Technical Service Bulletin

Product Description: **AMSOIL full flow oil filter SDF-20**

Subject: **Application Notice**

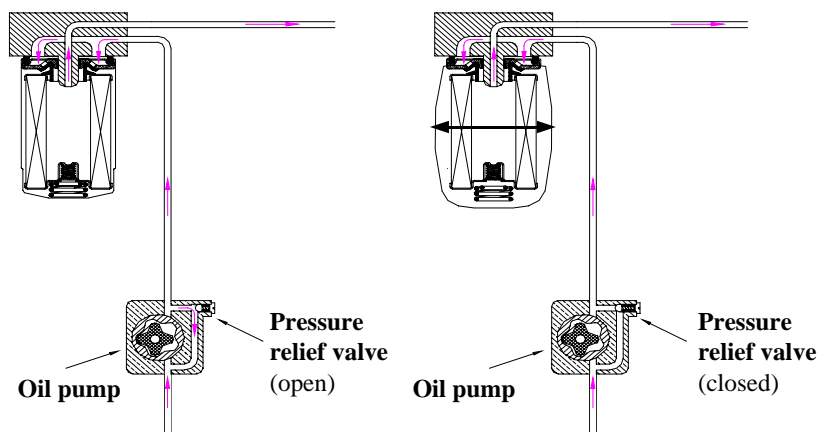
It has come to AMSOILs' attention that the engine oil system of some Mitsubishi applications may produce abnormally high oil pressure, exceeding the structural capacity of standard spin-on oil filters as well as the AMSOIL SDF-20. The high oil pressure is the result of improper operation of the pressure-regulating valve in the engine which may result in an over-pressurization if the lubricating system, damaging the oil filter.

Normal Operation:
Valve opens and closes

Abnormal Operation:
Valve remains closed

Due to these circumstances, AM-SOIL has decided to withdraw their recommendation for the use of the SDF-20 in place of the Mitsubishi part number MZ690116 oil filter. The AMSOIL SDF-20, will continue to be the recommended filter for many other applications not associated with this problem.
